Reactor Oversight Process Task Force FAQ Log
May 18, 2017

Dated June 5, 2017

FAQ 17-01
Grand Gulf June 2016 Power Change (Draft Response)

FAQ 17-02 (Draft Response)
Palo Verde Unit 3 Scram

Figure 1: Reactor Power during the Event

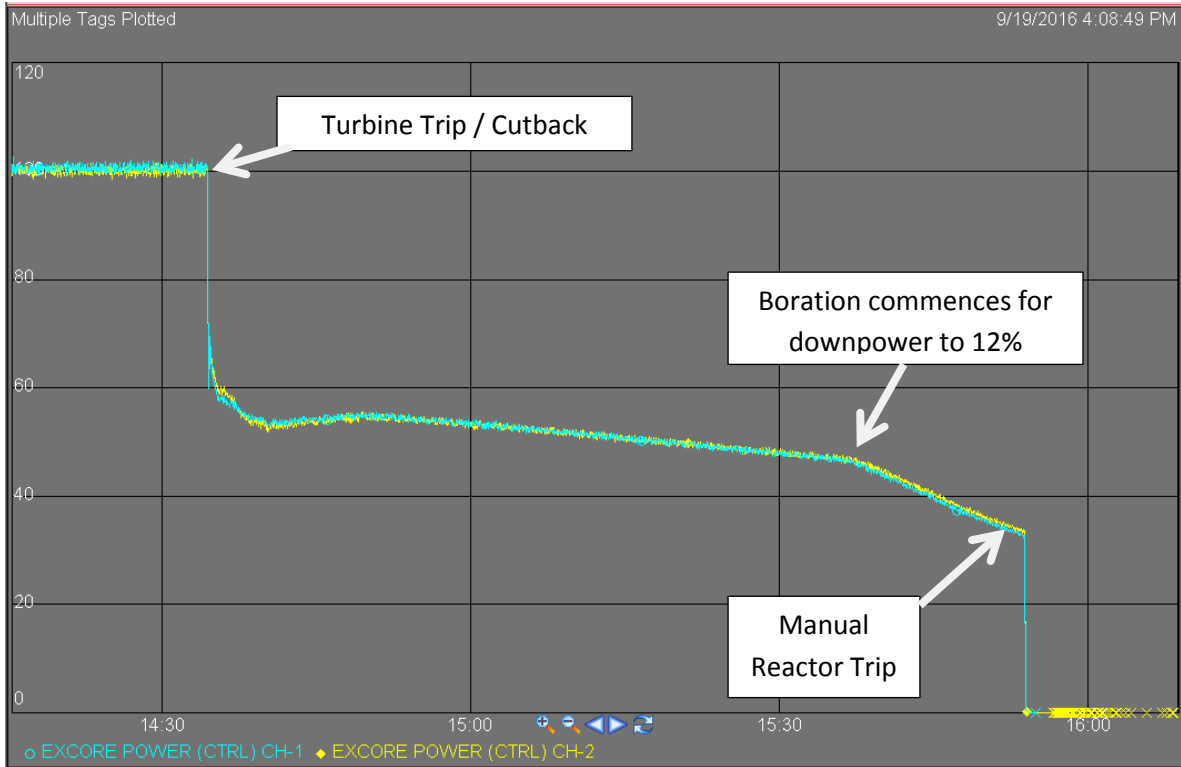
On September 19, 2016, the PVNGS Unit 3 main turbine tripped at 1434 with the unit operating at 100% power. A reactor power cutback occurred automatically, as designed. The control room staff began a power reduction to 12% using abnormal operating procedure 40AO-9ZZ08, “Load Rejection.” Subsequently, based on an assessment of need for troubleshooting and repairs, potential reactivity management challenges at the end of core life, and the uncertainty of cause which might delay the return to full power, the control room staff and plant management made a decision to complete a plant shutdown and place the plant in Mode 3 by tripping the reactor using step 3.24 of 40AO-9ZZ08 from approximately 34% power at 1554 to facilitate repairs. No additional, unexpected plant conditions were occurring that would require a plant shutdown other than the loss of the main turbine. Refer to the Figure 1 for a graphical display of the power changes during the event.

The NEI 99-02 example for a condition that would require counting an event both as an unplanned scram that occurred during an unplanned power change is given beginning on line 4 of page 17 of NEI 99-02. The intent of that discussion is to exemplify the disparate causes of the unplanned scram and unplanned power changes that required inclusion under both performance indicators. The unplanned scram was caused by the loss of condenser vacuum during an unplanned power change to conduct unplanned turbine generator repairs. The scram was due to a separate degrading condition that, by itself, could have resulted in a reactor scram.

The NEI 99-02 example is dissimilar from the September 19th, 2016, Unit 3 main turbine trip. The manual scram to complete the shutdown of the plant in order to troubleshoot and repair the cause of the main turbine trip was directly related to the cause of the main turbine trip itself and not to some other unrelated failure or degrading condition in the plant. No additional, unexpected plant conditions were occurring that would require a plant shutdown. The ultimate causal linkage of the unplanned power change (turbine trip) ending in a manual scram to correct the cause of the initiating turbine trip should count only as an unplanned scram as described in the referenced NEI guidance.

The resident inspectors generally agree with the event synopsis. However, there is an outstanding question of whether the manual trip was required by station procedures. The manual trip is permitted by the abnormal operating procedure, but it was not specifically directed. There is some question as to whether the plant could have been stabilized at 12% to take the turbine off line. Reactor Engineering was advising the operators to continue the down power rather than scram at the time the licensee's management made the decision to manually trip the reactor. If the plant had been stabilized at 12%, then a reactor trip would not have been required and there would be no issue of double counting; it would only register as an unplanned down power. PVNGS chose to manually trip the reactor, which was a conservative decision that was made at the discretion of the licensee, separate from and in no way directly caused by the spurious turbine trip or required by the procedure. Furthermore, had the station been unable to meet a Power Distribution Limit while continuing to down power that would have satisfied direct causation for inclusion as an unplanned scram only. But, as it stands, PVNGS ultimately made a separate decision to manually trip the reactor on less than 72 hours' notice. Therefore, it should be counted as a separate event under the current language of NEI 99-02, Revision 7.

The staff reviewed the procedure used by the licensee for the transient response and eventual plant trip (40AO-9ZZ08 Rev. 31), and discussed the event with the licensee and resident inspectors. The most pertinent parts of NEI 99-02 as pointed out by the licensee involve the definition of unplanned scram and when not to count a downpower that proceeds an unplanned scram. In this event, the initial downpower was caused by an unknown fault on the turbine control system. The decision to trip the reactor was predicated by that initial event. While some discretion was exercised by the licensee to trip the reactor at 34% power rather than at 12% power, both were per the abnormal procedure. As such, the downpower and scram are subject to the criteria in Section 2.1 of NEI 99-02, Revision 7 (page 17, lines 1-2): "Off-normal conditions that begin with one or more power reductions and end with an unplanned reactor trip are counted in the unplanned reactor scram indicator only."

This event should count as one unplanned scram and no unplanned power changes. No change to NEI 99-02 is required as a result of this FAQ.
